THE NEW YORK PUBLIC LIBRARY
MIDTOWN CAMPUS RENOVATION
STEPHEN A. SCHWARZMAN BUILDING

New York City Landmarks Commission
FOLLOW-UP SUBMISSION | March 5, 2019

Commissioner Comments from 2/19:

40th Street Terrace

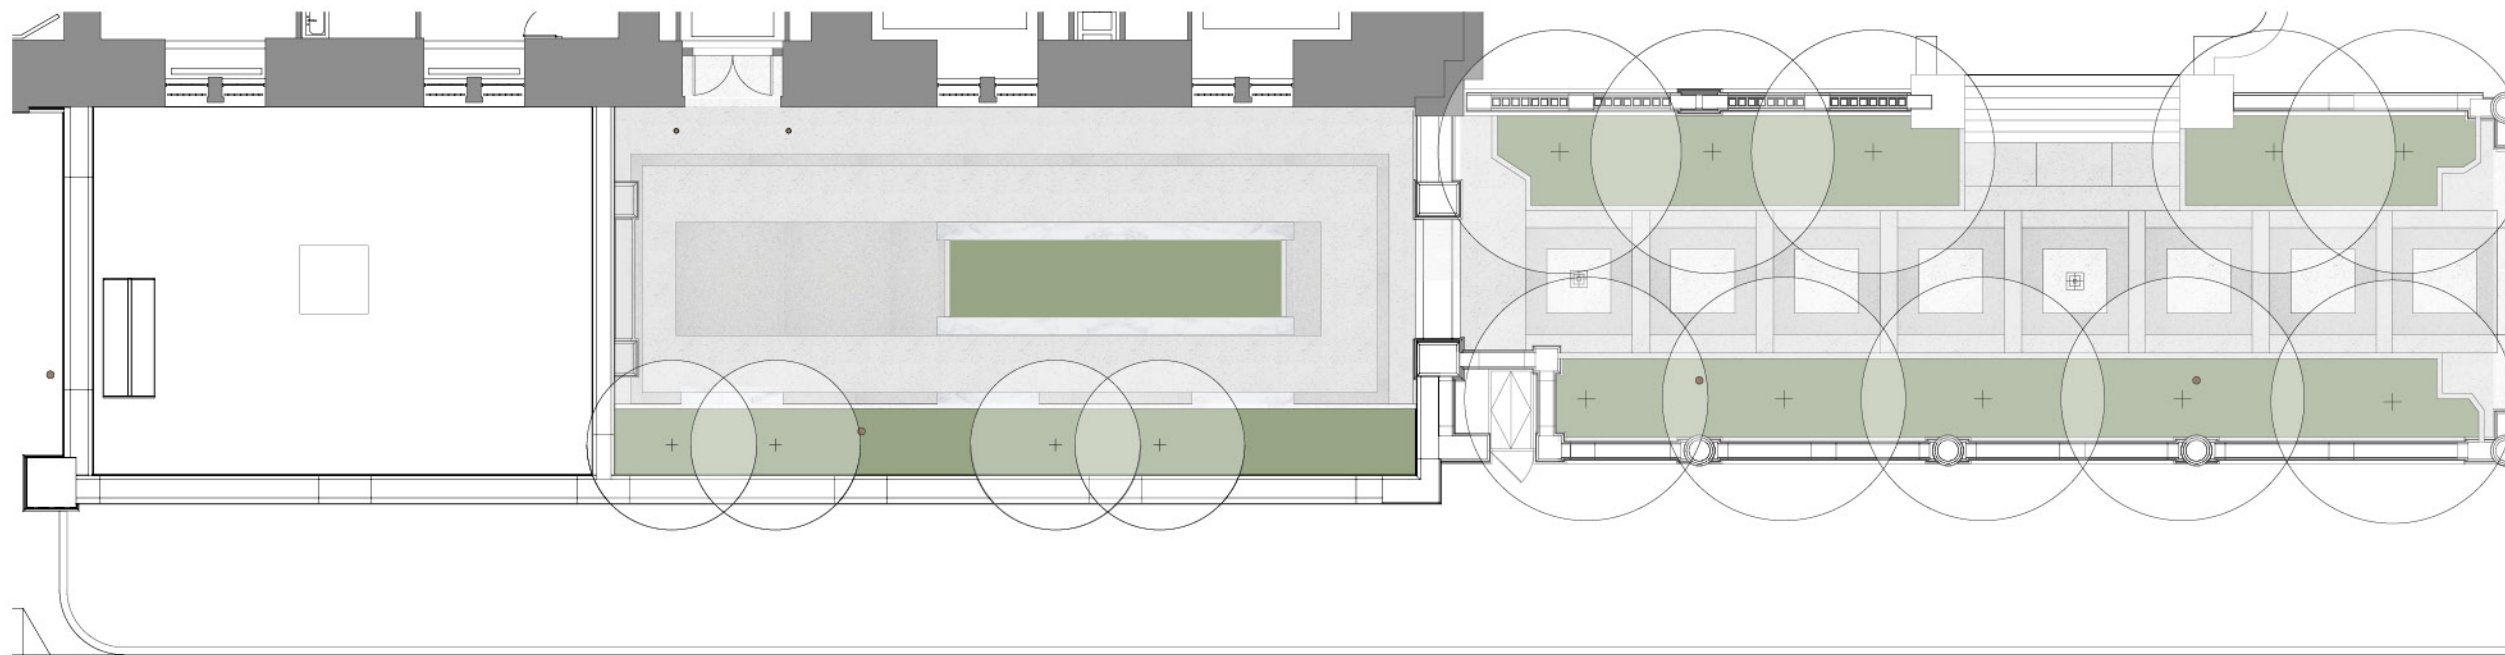
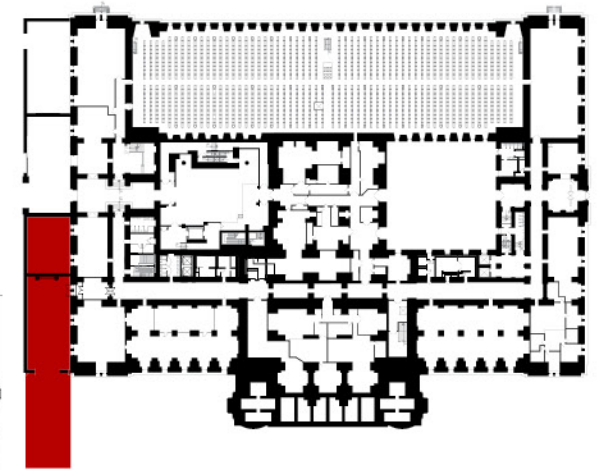
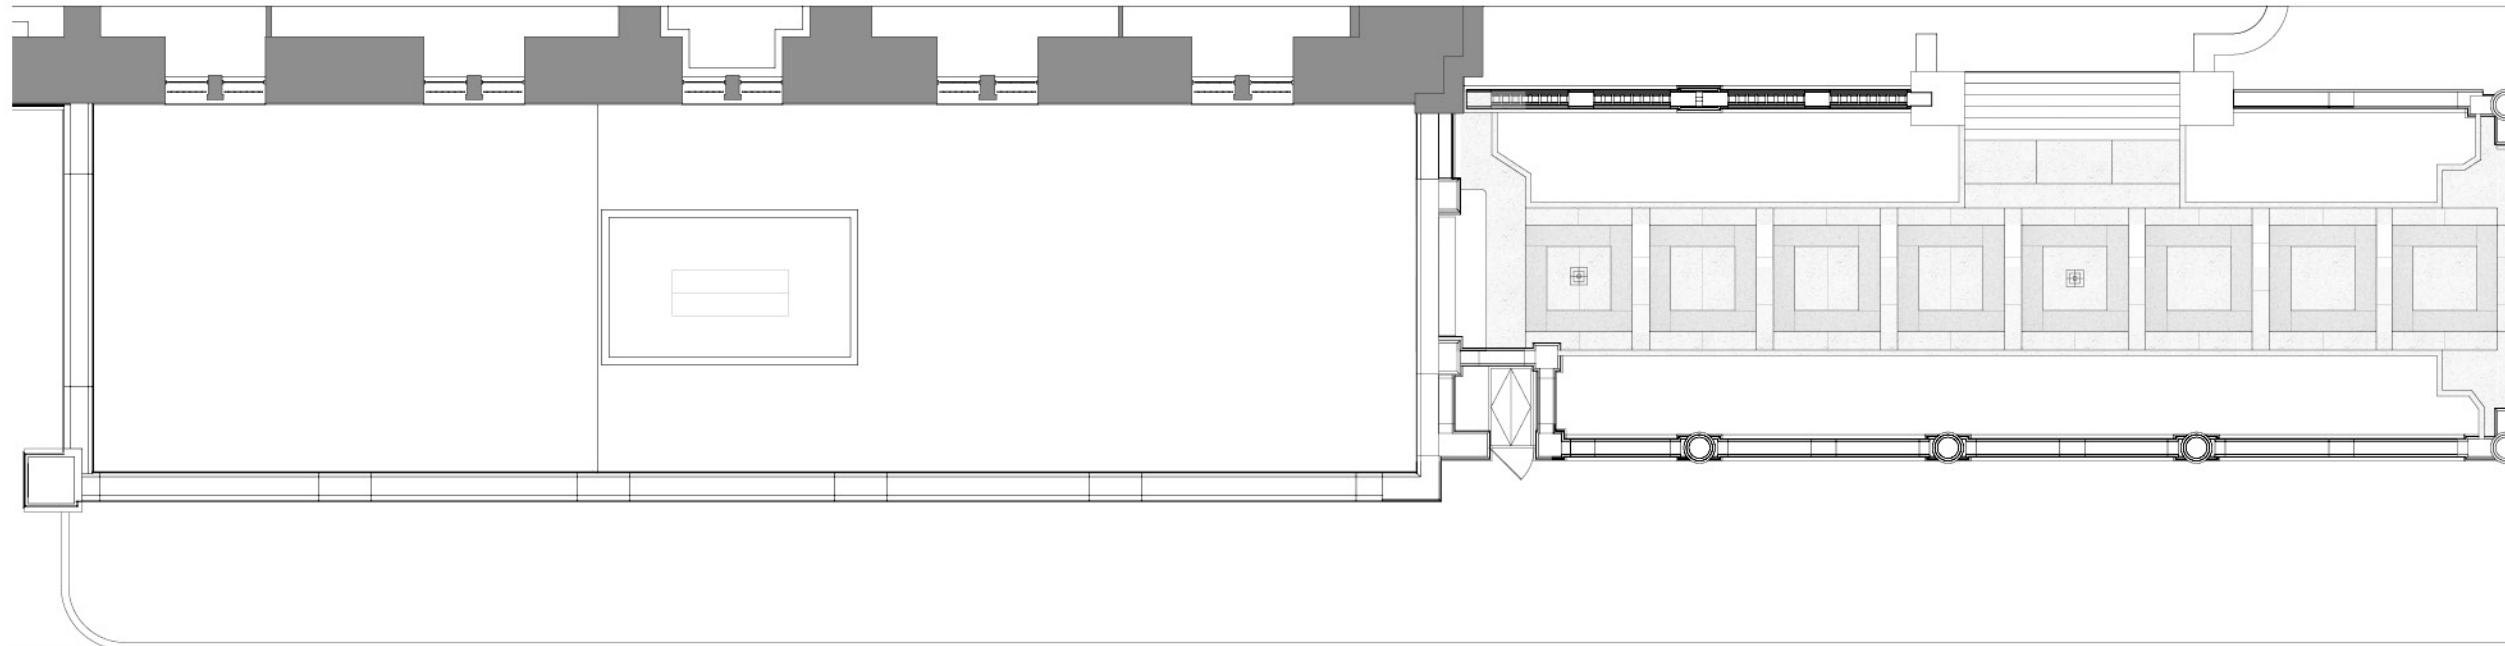
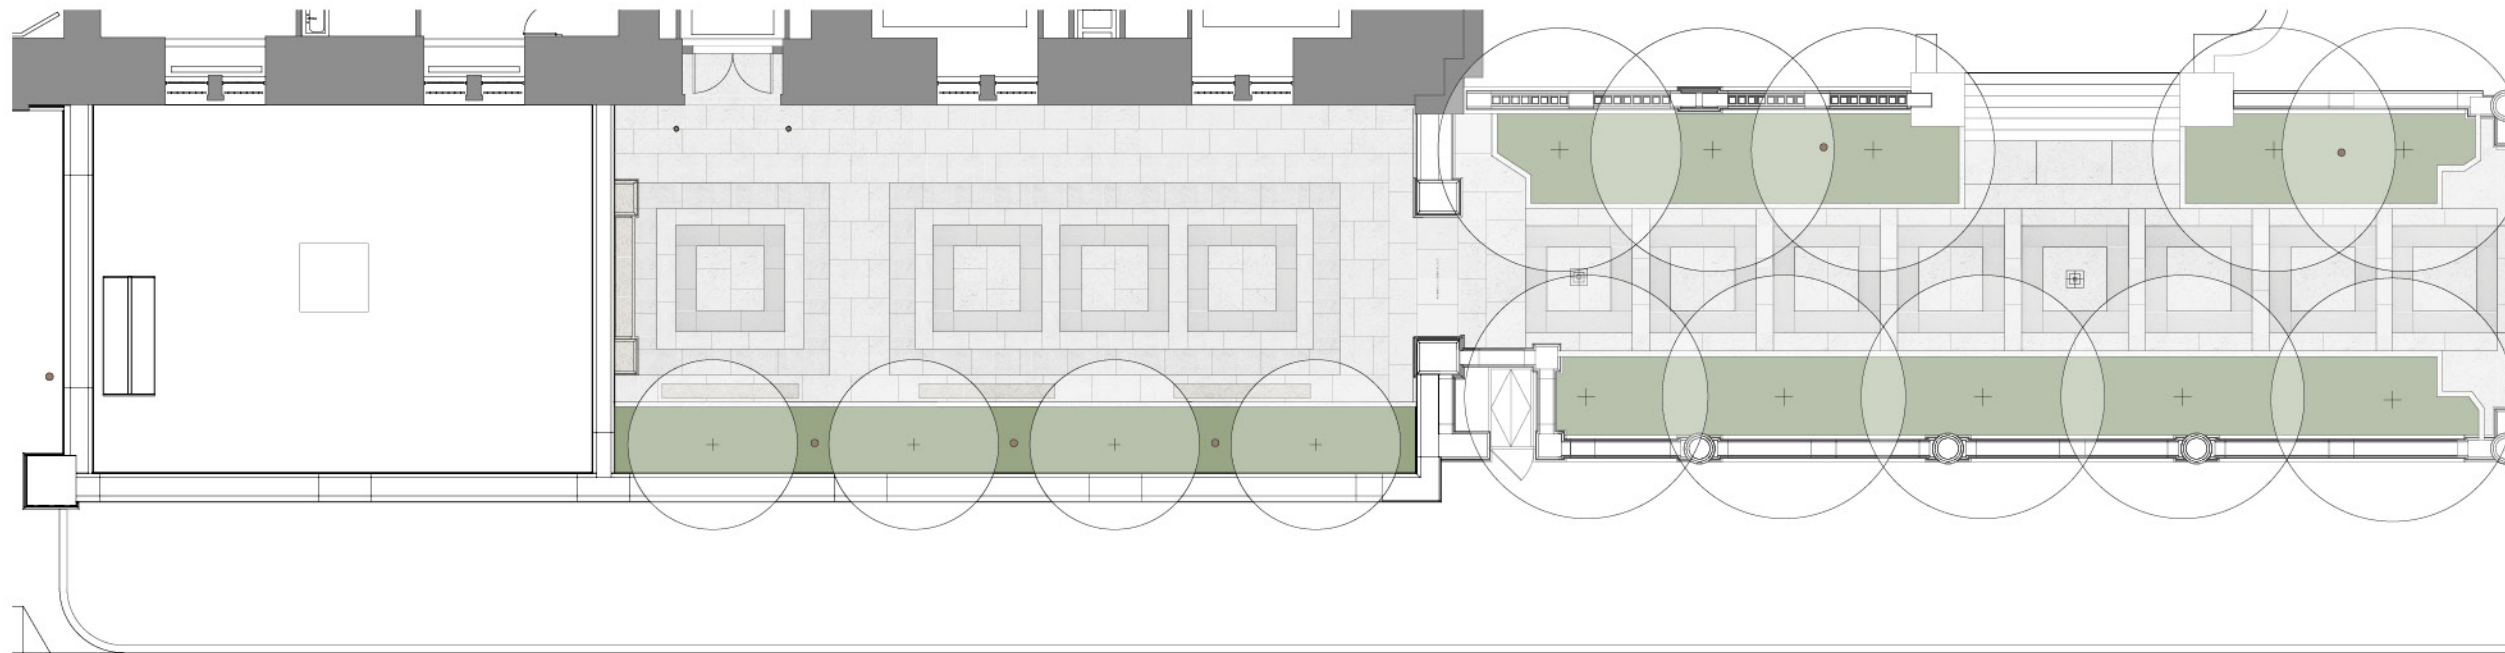
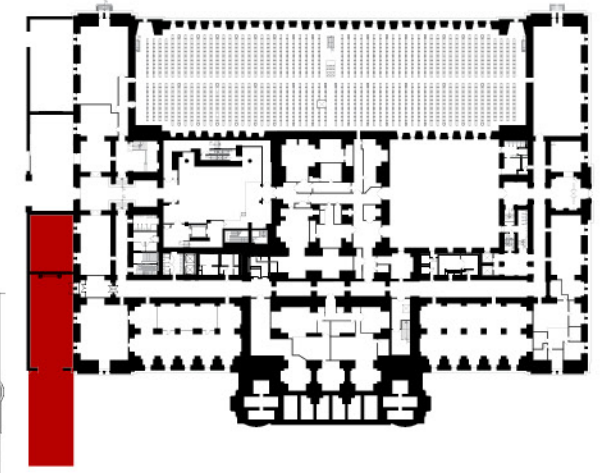
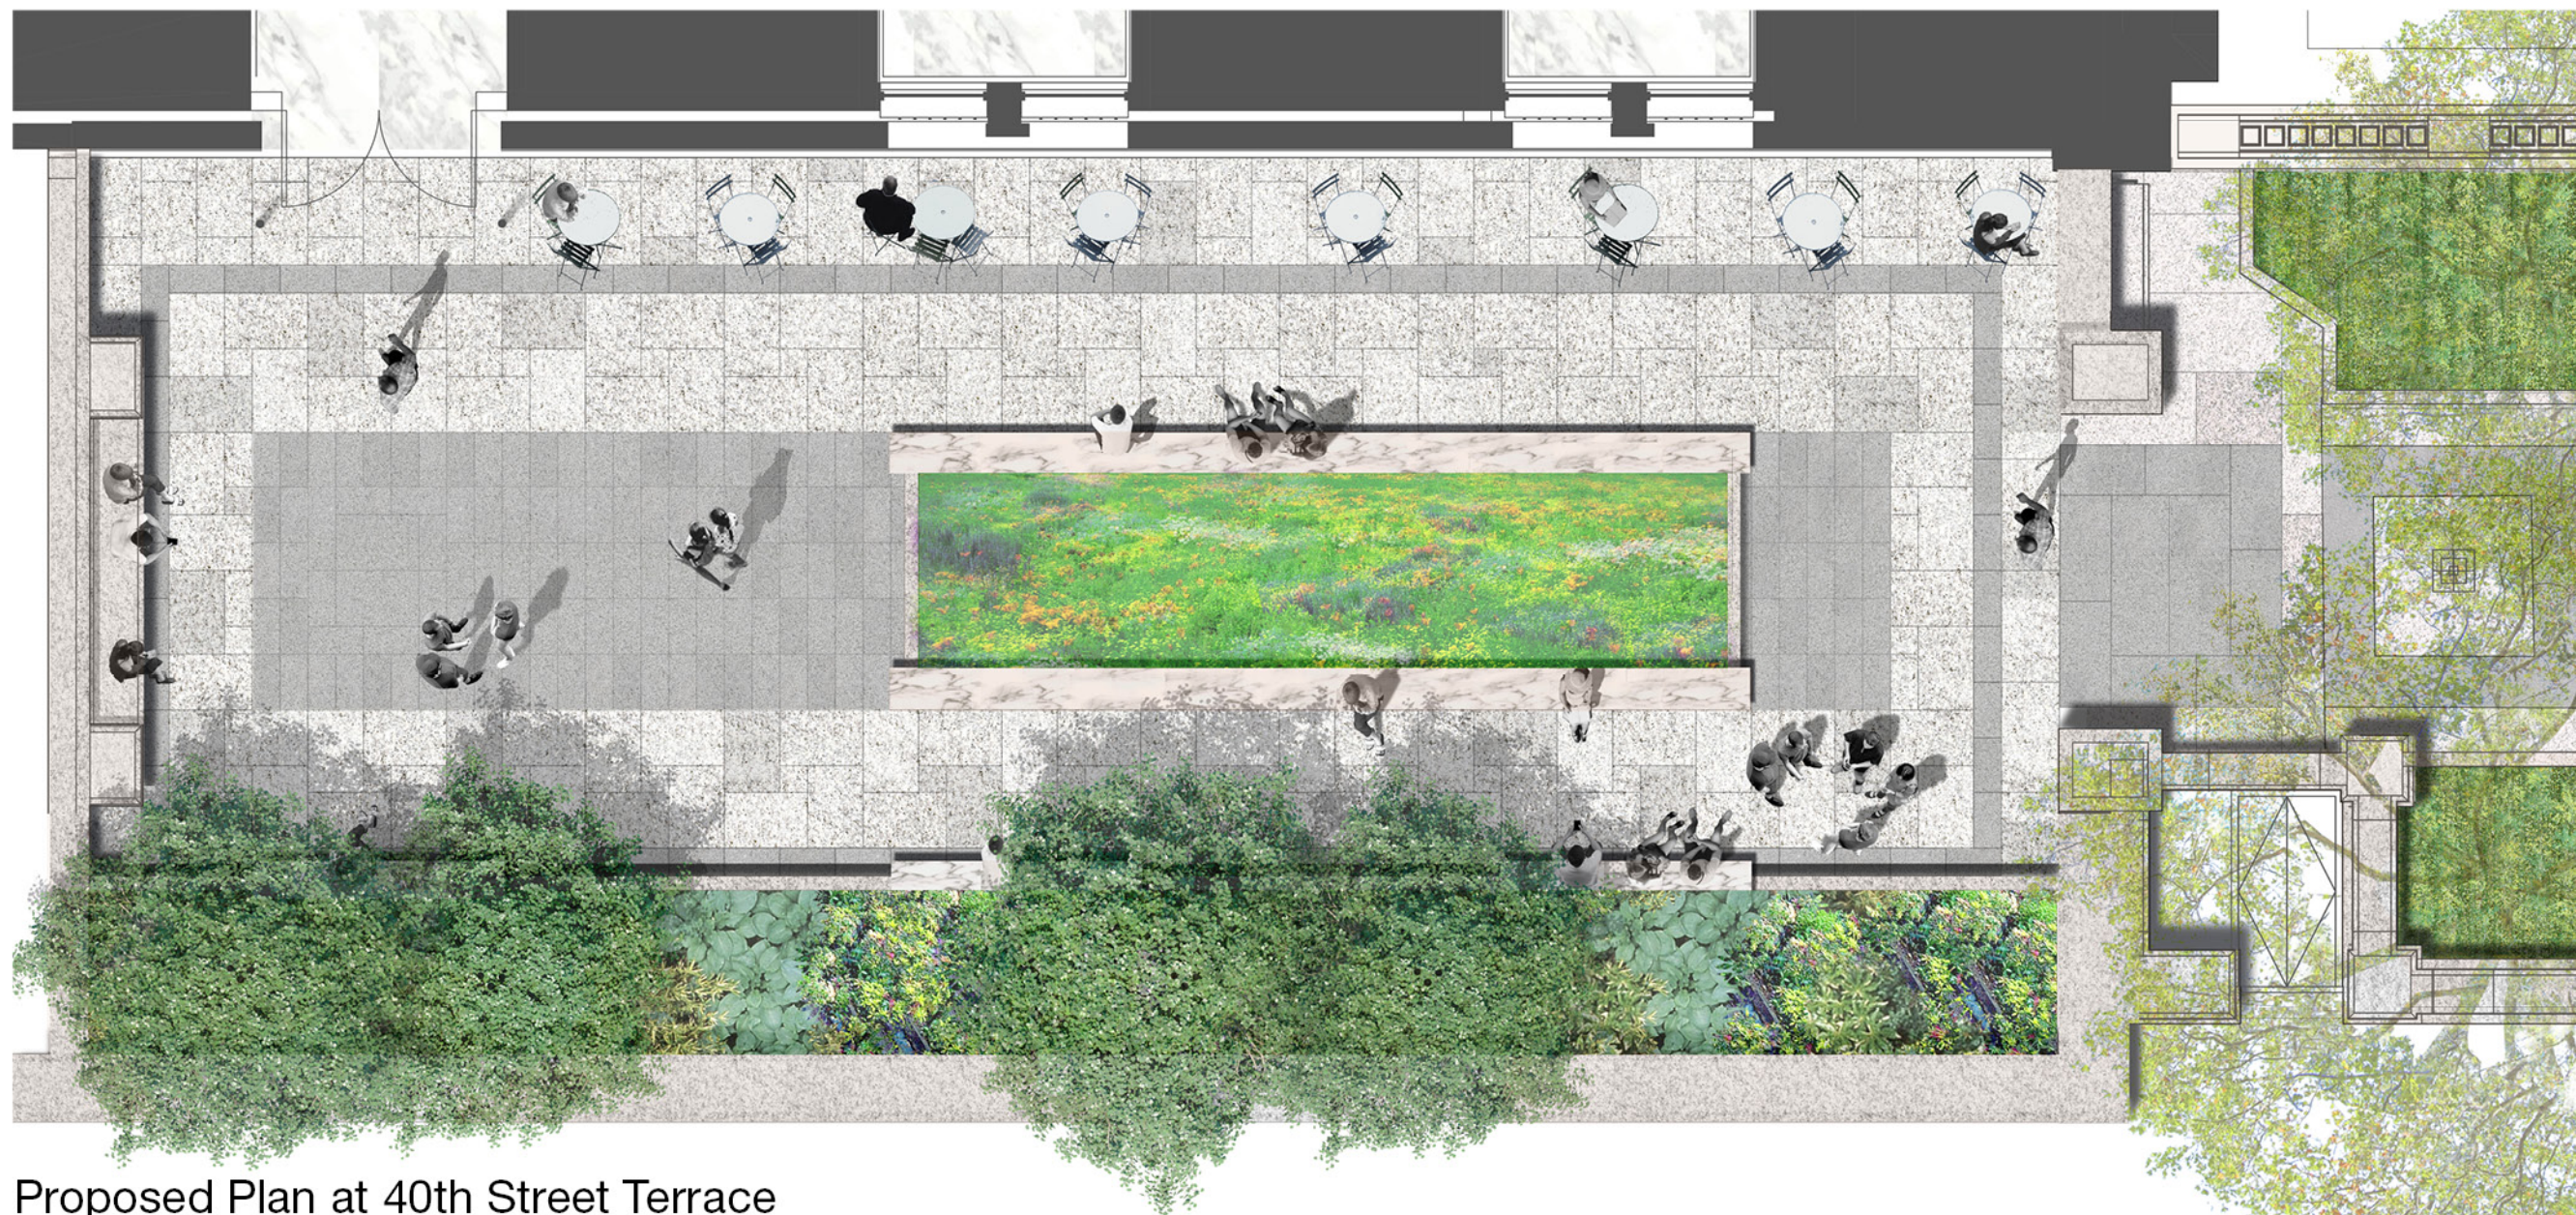
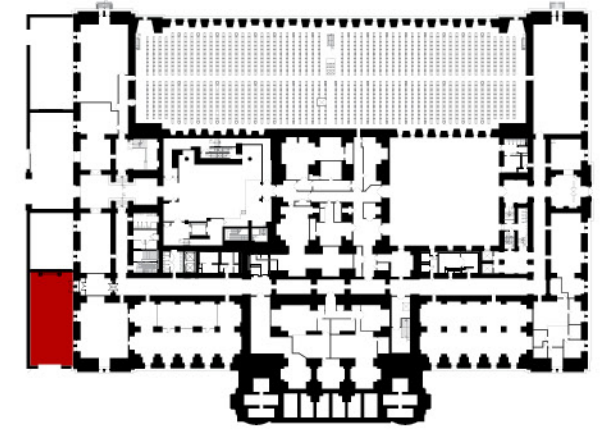
- Reconsider planter & paving design at proposed 40th Street Terrace
- Review lighting design at loading dock, specifically the number of poles
